**RE: 1327 Arcadian Trail NW
Grading and Drainage Plan
Engineer's Stamp Date: 03/24/2026
Hydrology File: G13D049
Case # HYDR-2026-00112**

Based upon the information provided in your submittal received 03/26/2026, the Grading and Drainage Plan **is not approved** for Grading Permit and Building Permit. The following comments need to be addressed for approval of the above referenced project.

DRAINAGE AND GRADING PLAN

1325 ARCADIAN TRAIL NW

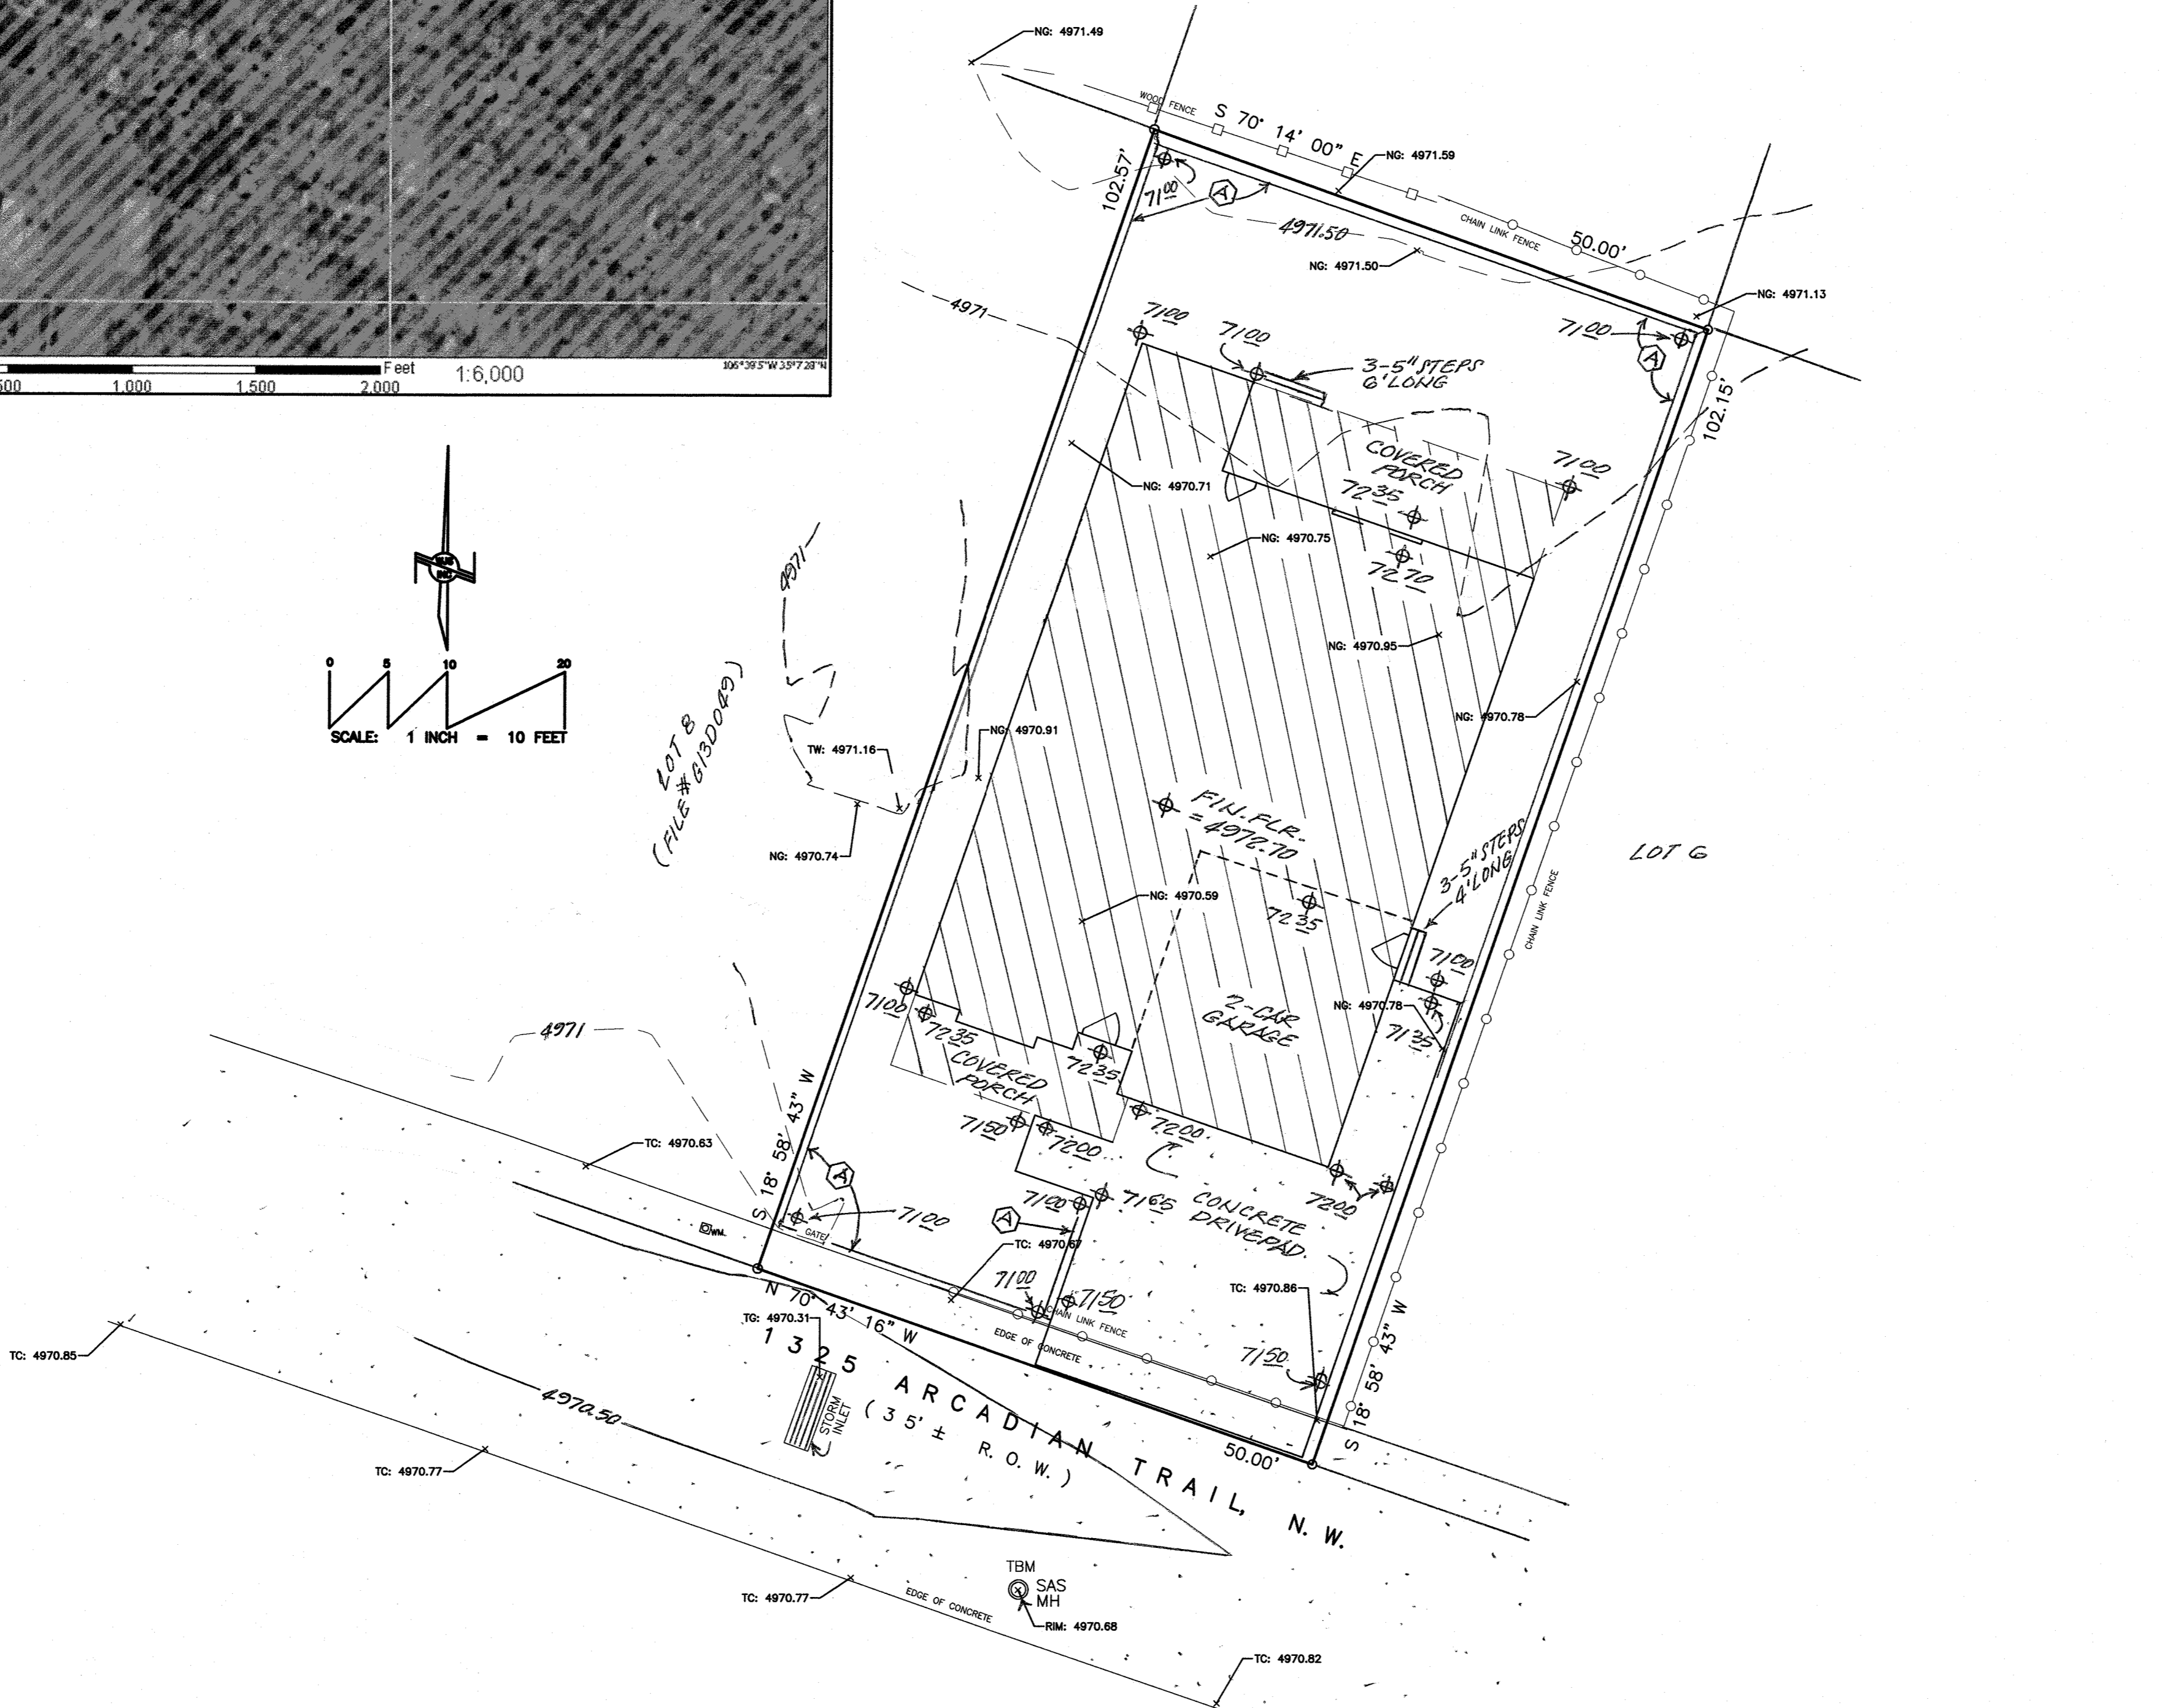
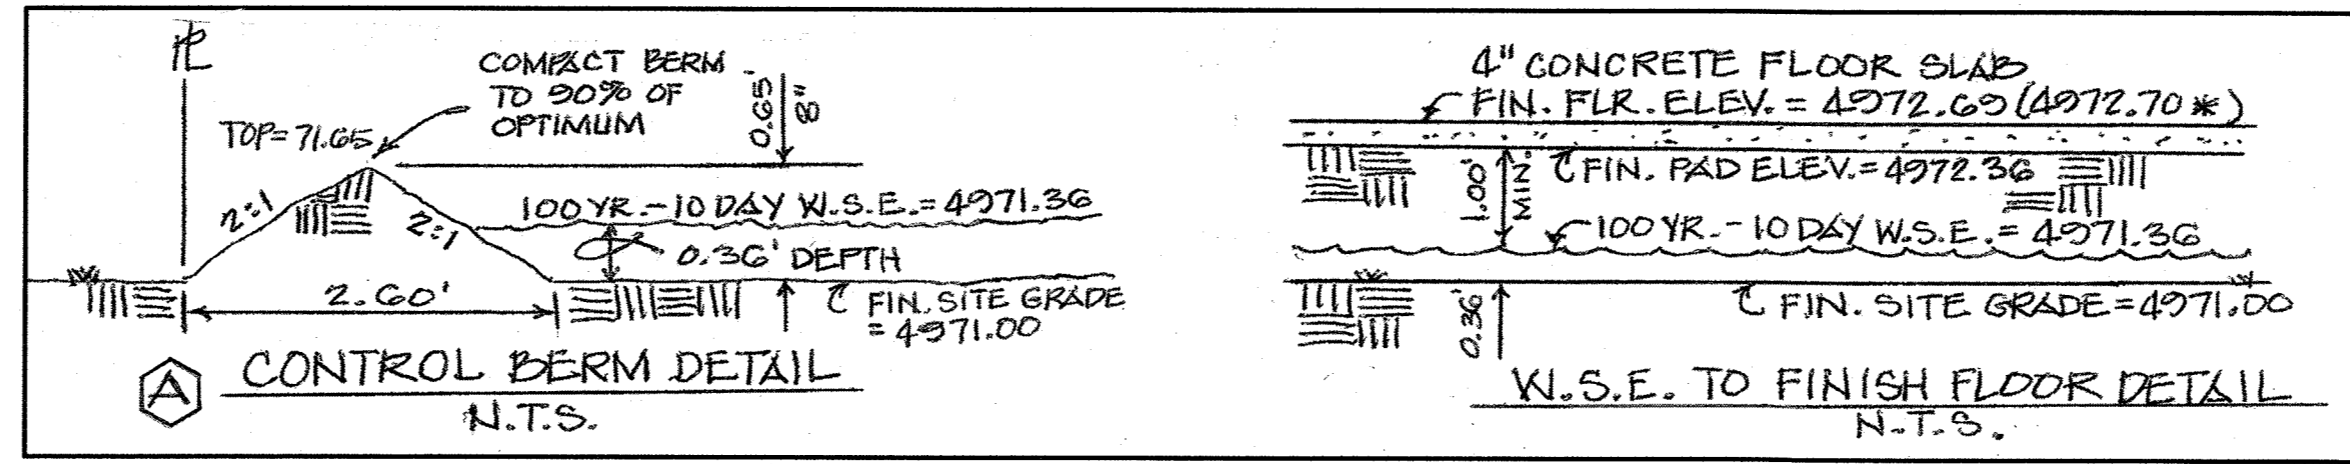
1. Per the IDO, the property owner of the property is responsible for building the adjacent half of Arcadian Trail NW to include curb & gutter, and sidewalk. The project will have to go to the Development Facilitation Team (DFT) for approval of the Infrastructure List.
2. Please show Finished Floor and Finished Pad elevations.
3. A permanent perimeter wall or barrier around the development is required to contain the 100-year 24-hour storm developed runoff.
4. Check calculations:

check calcs, I'm getting 0.0196

check calcs, I'm getting 0.026

5. Please include Vicinity Map Label. See example below:

6. Please provide the FIRM Map flood plain note with effective date. See example below:

*****100-YR./10-DAY STORM VOLUME CALCULATION :**
V10-DAYS = $V360 + AD \times (P-10 \text{ DAYS} - P360) / 12$ IN. FT.
V10-DAYS = $0.01044 + 0.07 \times (3.62 - 2.29) / 12$ IN. FT. = 0.01820 AC. FT. = 793.0 CU. FT.
DEVELOPED "C" = 0.05 AC. = 2,178.0 SQ. FT.
793.0 CU. FT. / 2,178 SQ. FT. = 0.36' DEPTH (100-YR./10-DAY STORM) *check calcs, I'm getting 0.026*
